Perfectionist's Power Amplifier

On the facing page are two pictorials, one each for the amplifier proper and the power supply. Below is a chart listing voltage readings at tube sockets and at other significant points throughout the amplifier.

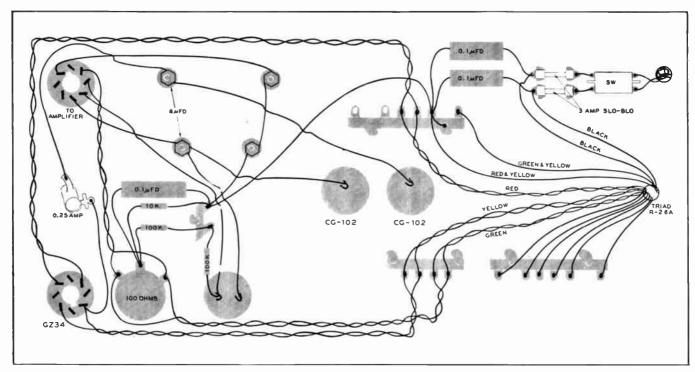
The pictorial shows, as unfortunately the January schematic did not, that the Acro TO-300 output transformer has the conventional output windings to match 4, 8, or 16-ohm speakers. The feedback network, although described by Mr. Zale as being evolved for 16 ohms, in practice effectively functions for all output impedances. In one or two instances a conflict arose between the parts list and the schematic—this should in all cases be resolved in favor of the schematic, and, of course, in favor of the parts values as listed on the facing page.

Finally — and, let's face it, we goofed — the power transformer was listed in the parts list as a UTC H-86, or equivalent. We searched our catalogues for an H-86, to no avail. Feeling that readers would similarly share our exasperation, we decided to purchase an "equivalent," and ultimately chose the Triad R-26A which, although it has more windings than we needed (the unused ones are shown on the pictorial soldered to an out-of-the-way terminal strip), came closest to matching the voltage and current requirements of Mr. Zale's design.
